**RE: Gillani on Modesto
8800 Modesto Ave., NE (Lot 10, Block 1, Tract 3, NAA)
Grading and Drainage Plan
Engineer's Stamp Date: 03/16/2022
Hydrology File: C20D068**

Based upon the information provided in your submittal received 03/28/2022, the Grading & Drainage Plan is **not** approved for Grading Permit. The following comments need to be addressed for approval of the above referenced project:

Grading & Drainage Plan

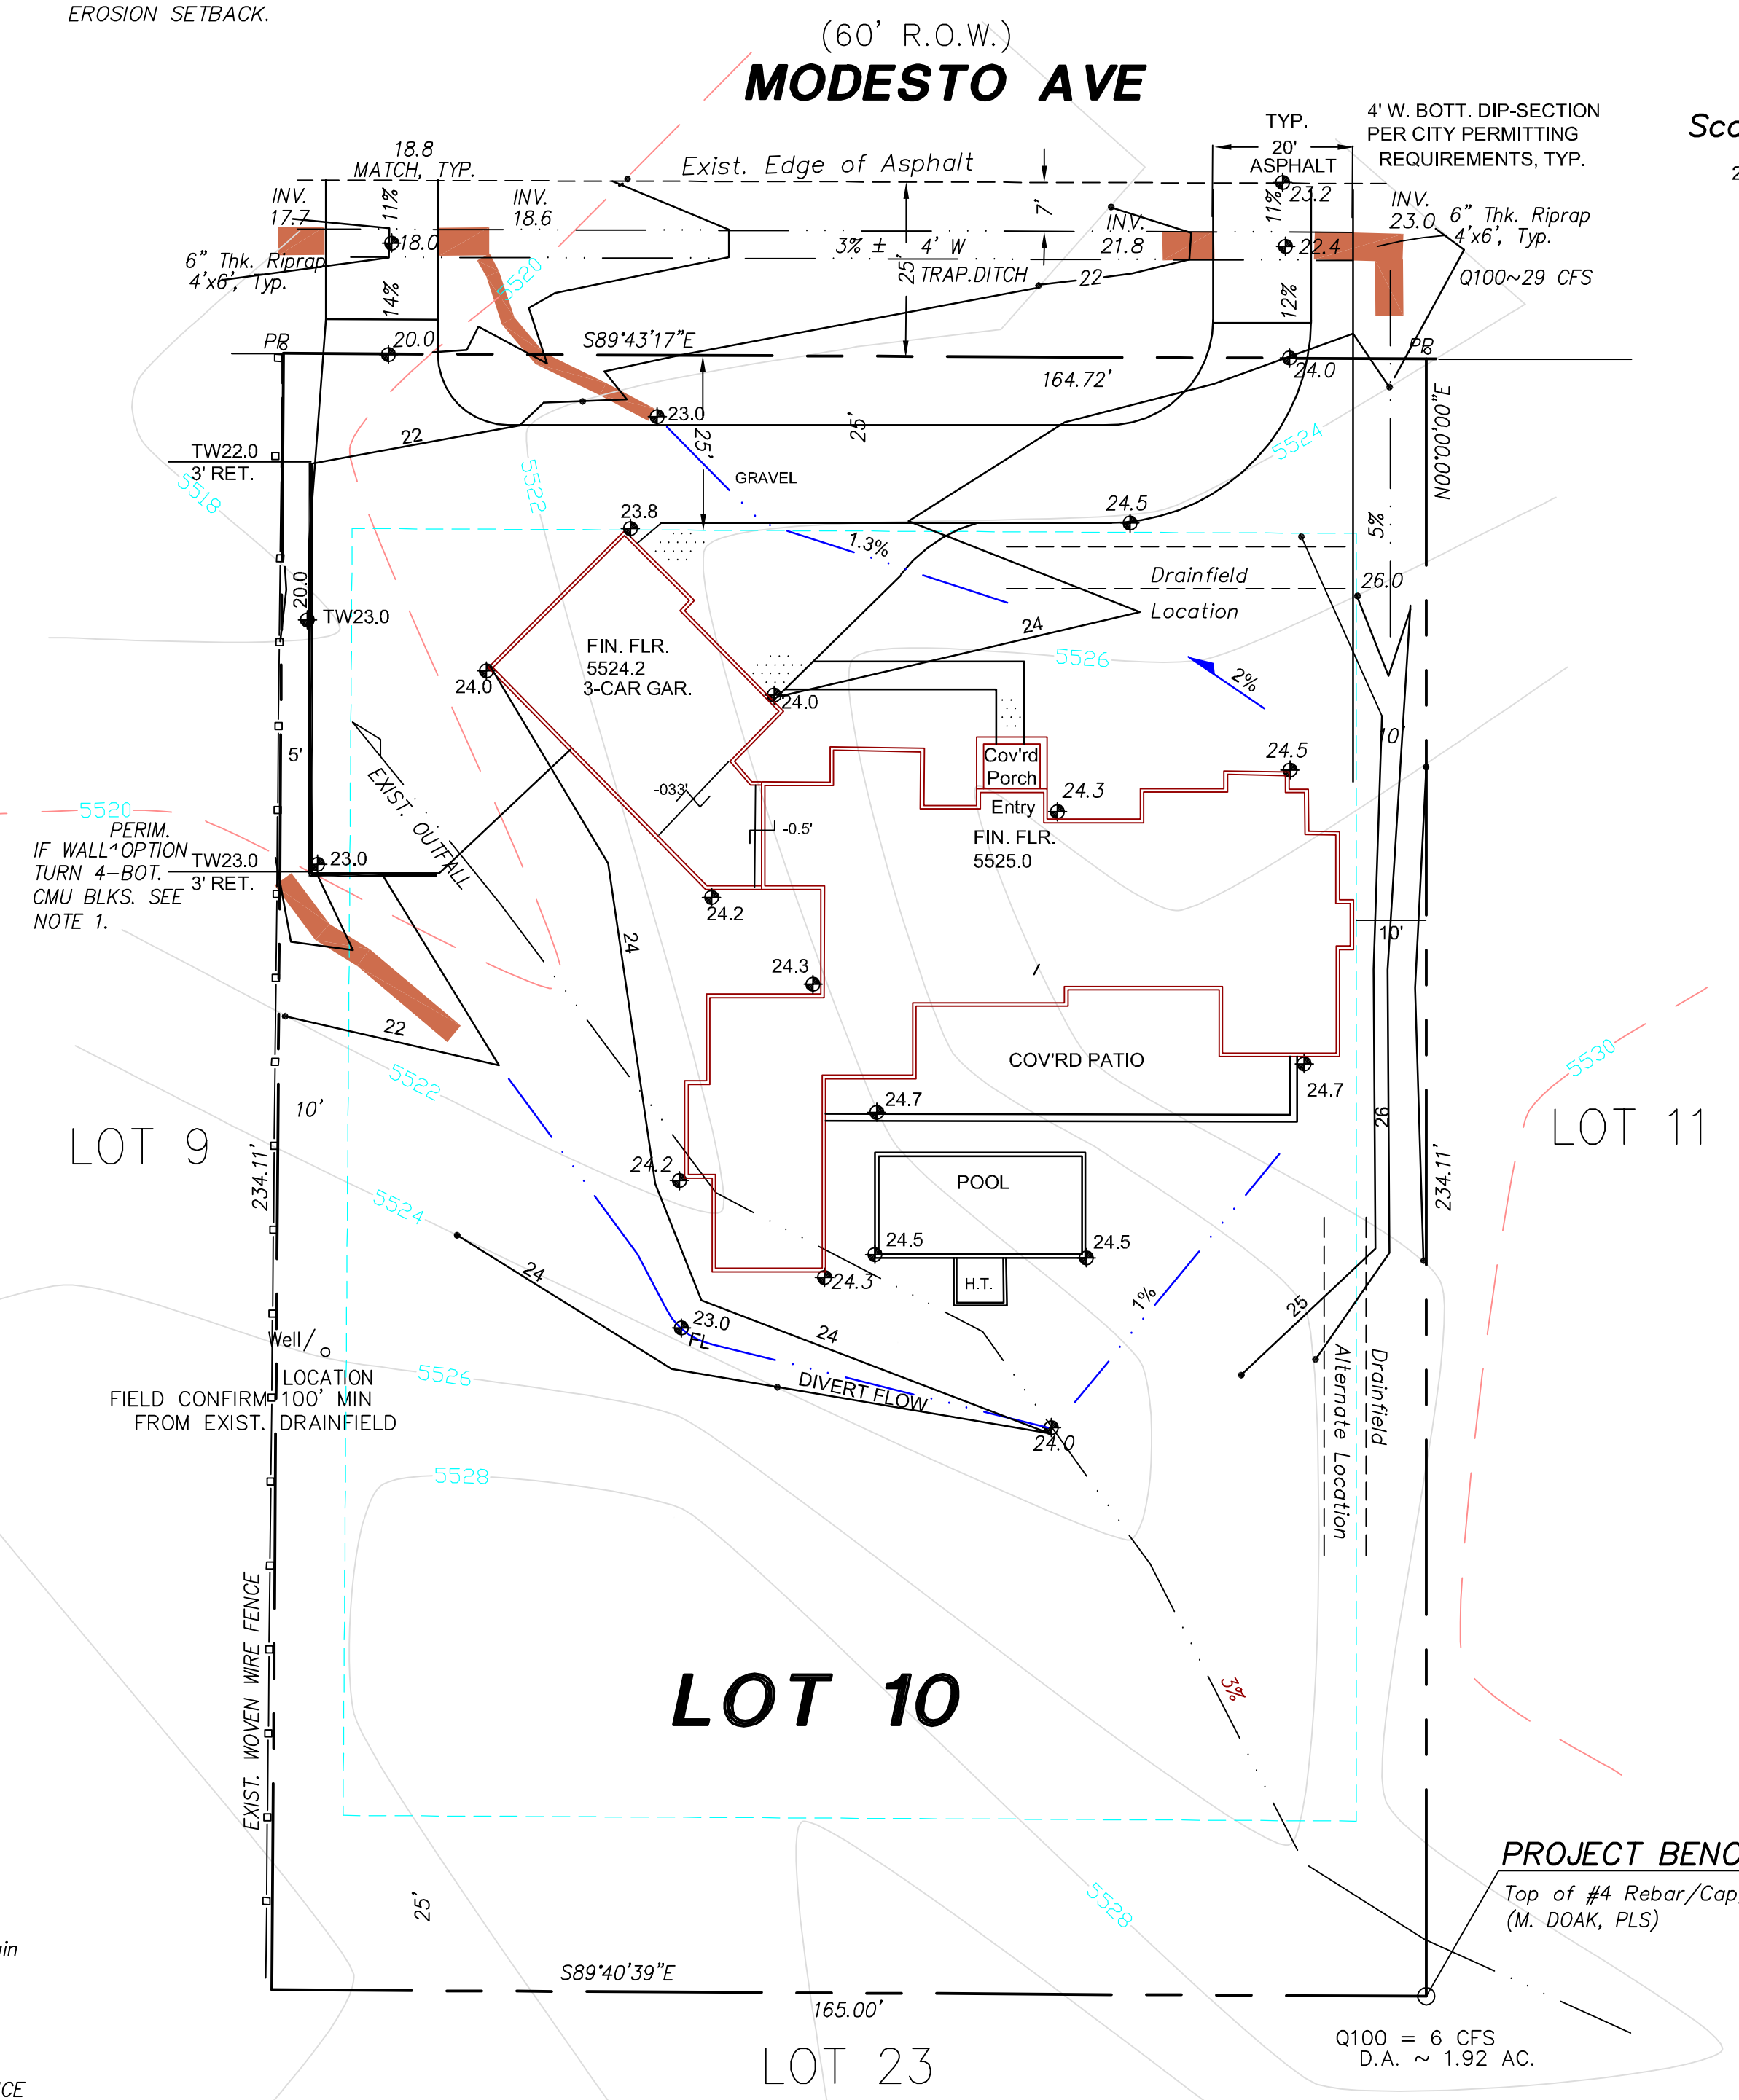
1. Please clearly show the adjacent downstream property's location where drainage will enter into their site and what is in place to protect against erosion (how will this tie to that as well).

2. Please clearly note what existing flow goes to that site and ensure it does not exceed that existing flow so that it does not overwhelm existing conditions for the adjacent property owner.

3. Is there a cross lot drainage easement to drain into the adjacent lot?
4. The site will need to go through DRB for platting to dedicate right-of-way and an infrastructure list generated with appropriate infrastructure requirements for the site that will include the entire frontage of the property to include curb, gutter, and sidewalk.

5. Please provide a section of the "trap ditch" that you called out to evaluate flow going through it.
6. Create a basin delineation to clearly identify flows and where they are going (Pre and post development).

7. Please only show proposed infrastructure for this permit. Future plans will still need to meet this G&D purpose or please propose it now and construct accordingly. This will/may cause confusion. When looking at it, the graphic clearly shows a proposed wall. With elevations that will require as-built info. Please simply show a faded line stating future wall and clearly note it is potentially for future construction.
